Subject: Responses to Cygna Questions from the Independent Assessment Program
Reviews
Comanche Peak Steam Electric Station
Independent Assessment Program - Phase 3
Texas Utilities Generating Company
Job No. 84042

COMANCHE PEAK STEAM ELECTRIC STATION
CYGNA POTENTIAL FINDING REPORT
(FISHER VALVES)
REF: CPPA-39,734

COMANCHE PEAK STEAM ELECTRIC STATION
CYGNA REVIEW QUESTIONS

TUGCO ANSWERS TO CYGNA'S QUESTIONS
OF OETTER 84042.018, 10/1/84

Figure A1

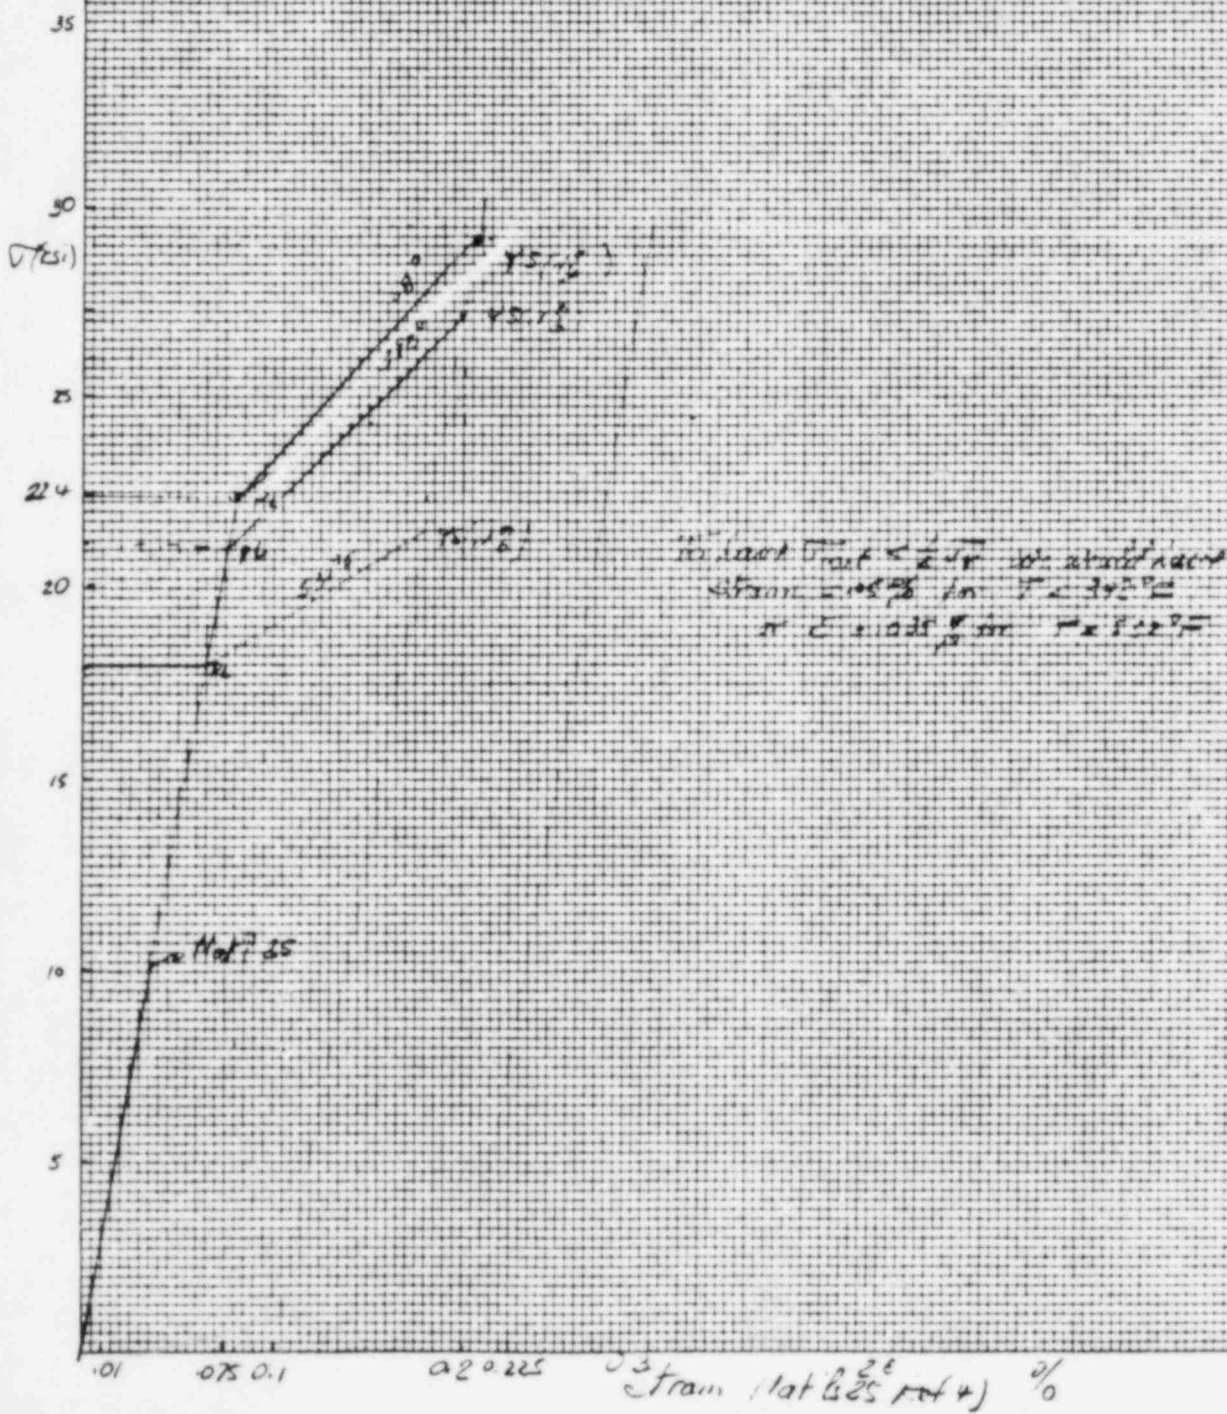
CYGNA has not received the A-36 steel stress relaxation graph and published report on stress relaxation (transcript page 77) nor a copy of TUGCO's answer to the NRC on this issue (transcript page 81). This information is necessary to complete our reviews.

of the chemical specifications. Figure A1 shows the stress strain curve of material 25 at various temperatures within our range of interest, i.e. less than 500°F. This curve is used to illustrate the meaning of material relaxation (as opposed to overall mechanical relaxation which will be discussed later) for monotonic loading, i.e. noncyclic. For the material to relax, plastic strain is required. Ferritic steels like A-36 exhibit a well defined proportional limit at which plastic strain begins. The yield strengths of these materials are given at the 0.1% or 0.2% elastic strain offset (in general it is the latter, although for material 25 the former is used). In figure A1 the details of the stress strain curve between the proportional limit and the yield point are not shown. From that figure, if the material is strained below the proportional limit no material relaxation will occur. Strains in excess of the proportional limit will result in relaxation, the amount of relaxation being proportional to the amount of plastic strain (or volume of material that has yielded). At room temperature the strain corresponding to the proportional limit is about 0.075 percent. At that level of initial strain, therefore, little or no relaxation should be expected. Figure A4, developed using the information on Material 25 of ASTM DS60, shows that the relaxation is negligible. At 532°F, the strain corresponding to the proportional limit point is 0.065 percent. Since the material 25 has been strained to .075% relaxation should be expected. Moreover, the heating of the material from room temperature to 532°F and the return to

FIGURE 1

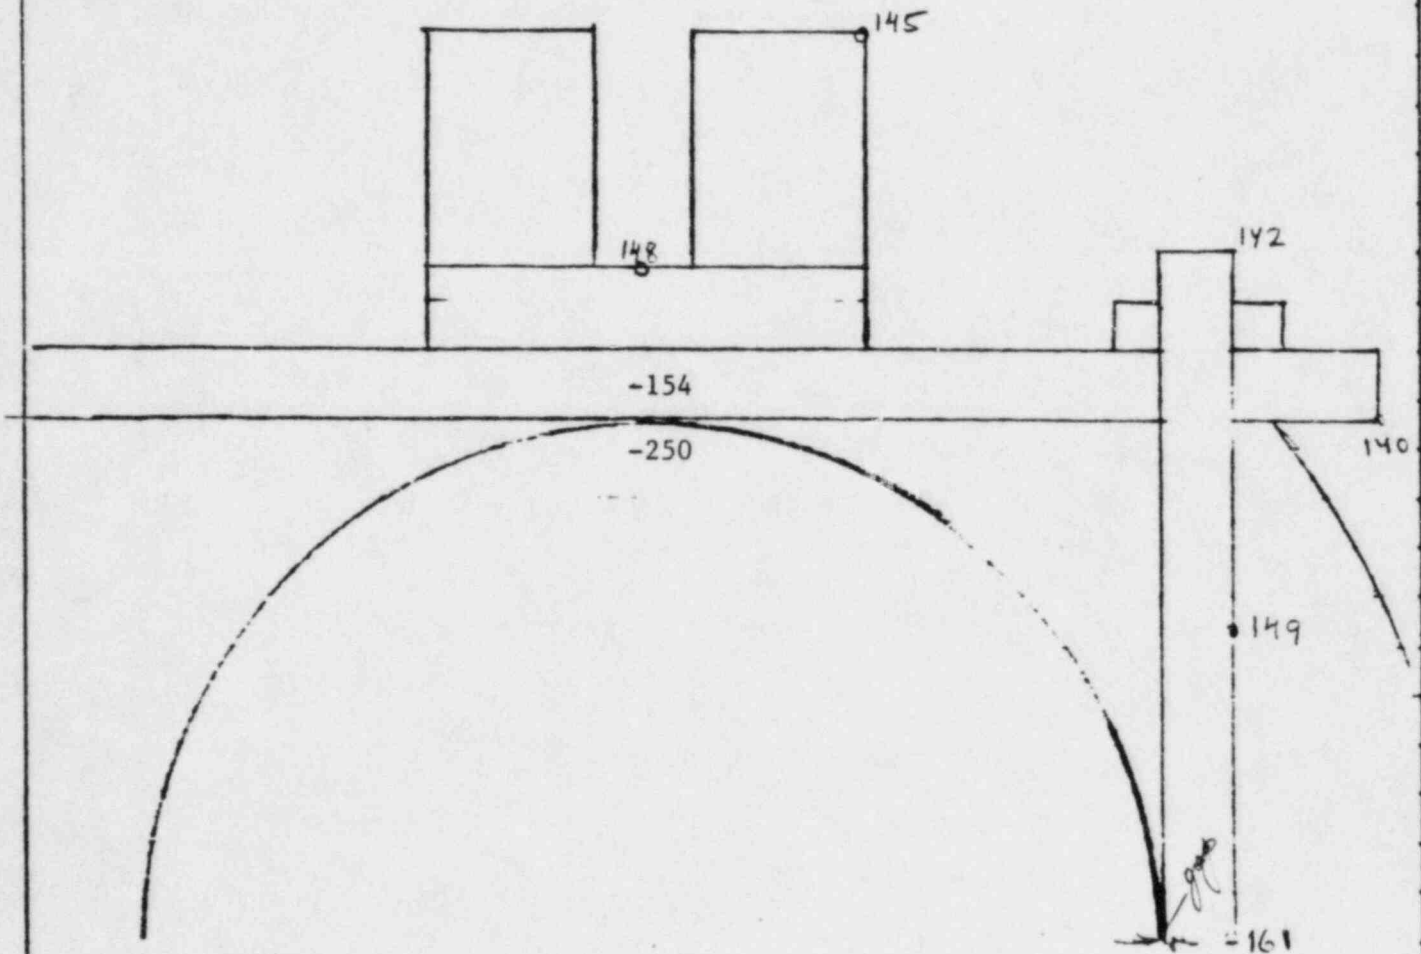
2. Q. CYGNA Question 4 (transcript page 32)
Re: Use of 250°F for 10" Pipe

Results of the analyses are shown in Figure 1 for the uninsulated case. In Figure 2 similar results are shown for the insulated case. The only difference between the latter analyses and that of the uninsulated configuration are the pipe temperature, which in the latter instance is 350°F, and the presence of insulation.
